Access Compliance Report

Public Rights-of-Way

(Curb Ramps)

Intersection ID: 51704	Main Street: IKEA_BV	Cross Street: N/A	Location: E
ADA ID: 1346298FE5FB	Ramp Type: BlendTrans1	Initial Pass/Fail: Fail	Overall Compliance: No
Severity Score: 12.5			
Codes/Mitigation Info/Possible Solution		Field Measurements/Component Compliance

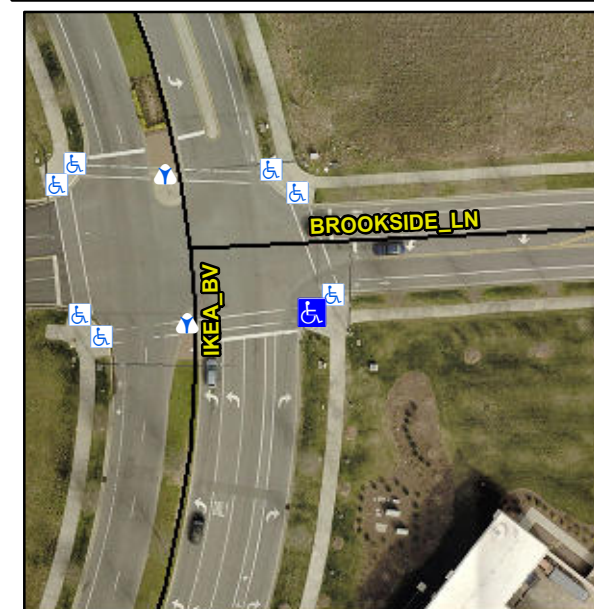
Not Found, R304.5.3

Compliance	Description	Data	Compliance	Description	Data
N/A	Ramp Length (in)	146.0	Yes	BlendTrans Slope (%)	3.5
Yes	Ramp Width (in)	48.0	No	BlendTrans XSlope (%)	5.9
N/A	Flare Type LT	N/A	N/A	Flare Type RT	N/A
N/A	Flare Slope LT (%)	N/A	N/A	Flare Slope RT (%)	N/A
N/A	Flare Traversable LT?	N/A	N/A	Flare Traversable RT?	N/A
N/A	Landing Length (in)	N/A	N/A	DWS Provided?	N/A
N/A	Landing Width (in)	N/A	N/A	DWS Contrast?	N/A
N/A	Landing Slope (%)	N/A	N/A	DWS Length (in)	N/A
N/A	Landing X Slope (%)	N/A	N/A	DWS Full Width?	N/A
N/A	Landing Curb? (Y/N)	N/A	N/A	DWS Offset (in)	N/A
N/A	Shared Landing?	N/A			
N/A	Gutter Ponding?	N/A	N/A	Gutter Slope (%)	N/A
N/A	Gutter Lip Ht (in)	N/A	N/A	Gutter X Slope (%)	N/A
N/A	Painted X Walk1?	Yes	N/A	Painted X Walk2?	N/A
	X Walk 1 Direction	To W		X Walk 2 Direction	N/A
	X Walk 1 Width (in)	69.0		X Walk 2 Width (in)	N/A
	X Walk 1 Slope (%)	3.1		X Walk 2 Slope (%)	N/A
	X Walk 1 X Slope (%)	1.2		X Walk 2 X Slope (%)	N/A

N/A	Ramp inside XWalk1?	Yes	N/A	Ramp inside XWalk2?	N/A
	Road Slope (%)	1.2		Clear Space?	N/A
	Road X Slope (%)	3.1	N/A	Clear Space to XWalk (in)	N/A
N/A	Any Obstructions?	N/A	N/A	Storm Grate/Utility Hazard?	N/A
	Obstruction Type			Storm Grate/Utility Type	
		N/A			N/A
			Yes	Surface Condition? (G/P)	Good
			No	Curb Slope (%)	23.0

Remove & Replace Curb Ramp With Two New Directional Ramps or Equivalent.
